OIL - INCORPORATE NEW NO.5 BEARING OIL FEED TUBE SUPPORT BRACKET ATTACHING BOLTS -
CATEGORY CODE 4 - MOD.ENG-79-0012

V2500-ENG-79-0012

SERVICE BULLETIN

Replacement of attaching bolts
Fig.1

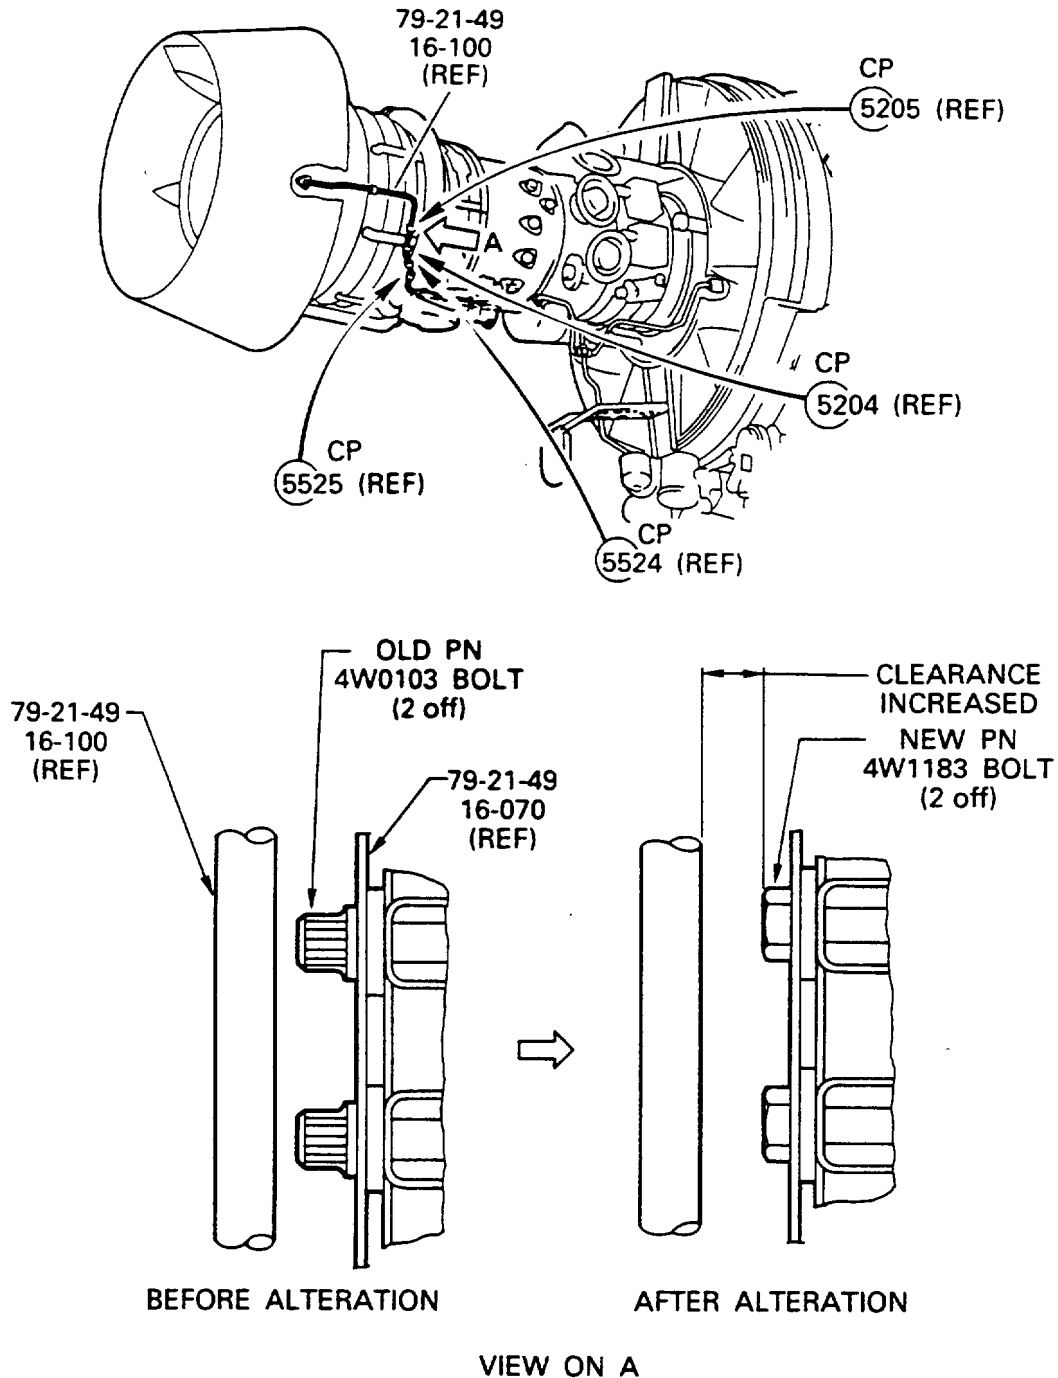
Insufficient clearance may exist between the No.5 bearing oil feed tube and the bolts attaching to the the bracket.

- (a) The new bolts of hexagon head type are introduced in lieu of the existing bolts of double hexagon head type.
- (b) This provides sufficient clearance, approximately 0.25in. (6,35 mm).

- (1) Remove 4W0103, Bolts (79-21-49, 16-072) (2 off) from the engine.
- (2) Install 4W1183, Bolts (79-21-49, 16-072) (2 off) in position of the engine and torque the bolts to 36 to 45 lbfin (4,00 to 5,00 Nm).

NOTE: Lubricate all threads and abutment faces of the bolts with CoMat 10-039 engine oil.
